**GEOTECHNICAL INVESTIGATION  
PROPOSED RESIDENTIAL SUBDIVISION  
PART 1, PLAN 5R-10284  
2050 DUNROBIN ROAD  
WEST CARLETON WARD  
CITY OF OTTAWA, ONTARIO**

Issued in support of the Subdivision Agreement  
Revision 1 – Issued in Response to City Review Comments

## Response to Geotechnical Review Comments

The following geotechnical review comments were received May, 2022. Kollaard Associates Inc.'s response is provided in italics immediately after each comment for clarity:

FOOTING BEDROCK -  
OVERBURDEN TRANSITION TREATMENT

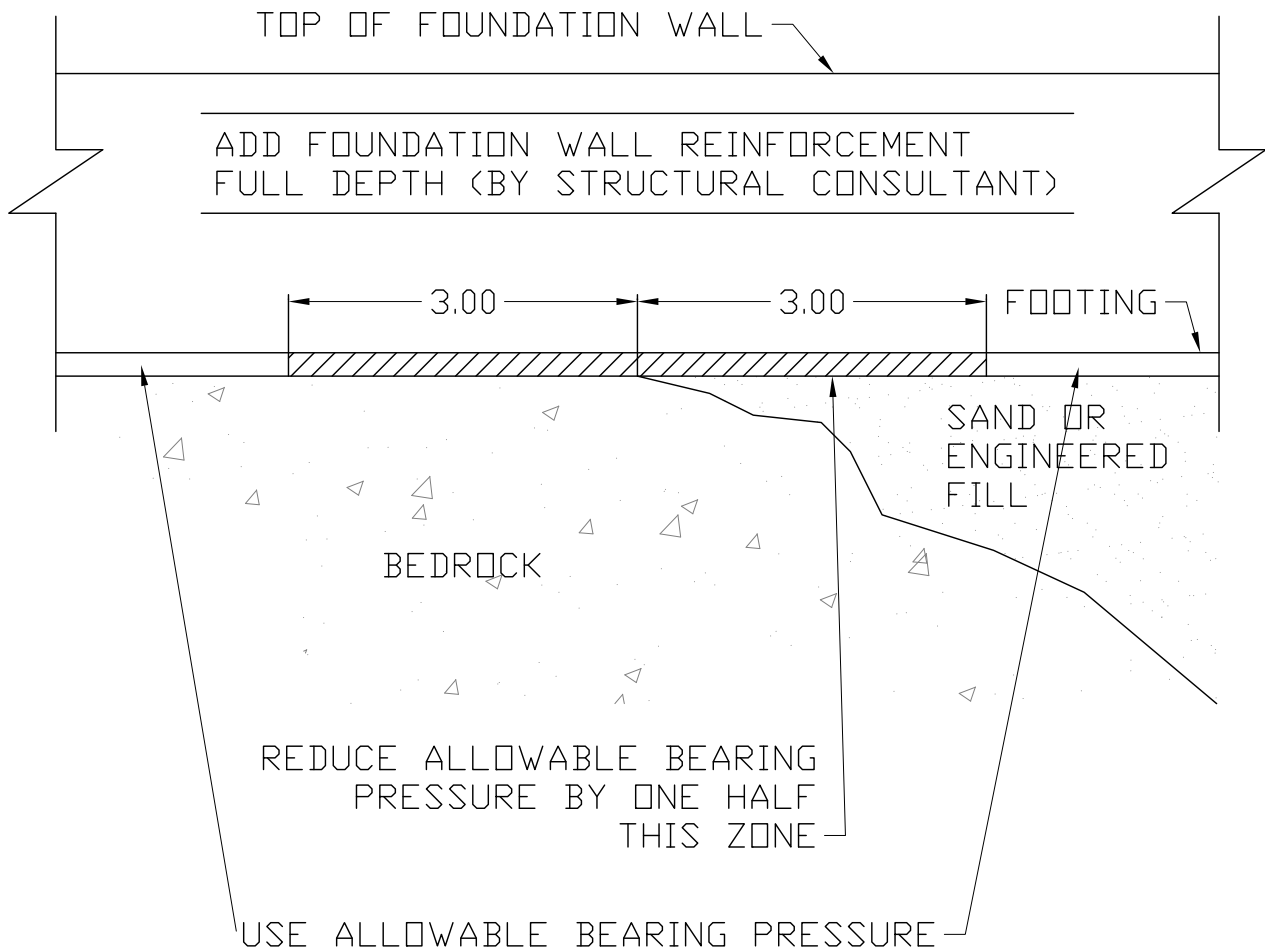
9. Please provide the recommended insulation detail, mentioned in Section 5.2.6 of the report.

To minimize the potential for foundation cracking where footings will be founded on both overburden materials and bedrock, it is suggested that the foundations walls in the transition zone be suitably reinforced. Suggested foundation treatment for overburden/bedrock transition areas are provided in the attached Figure 3.
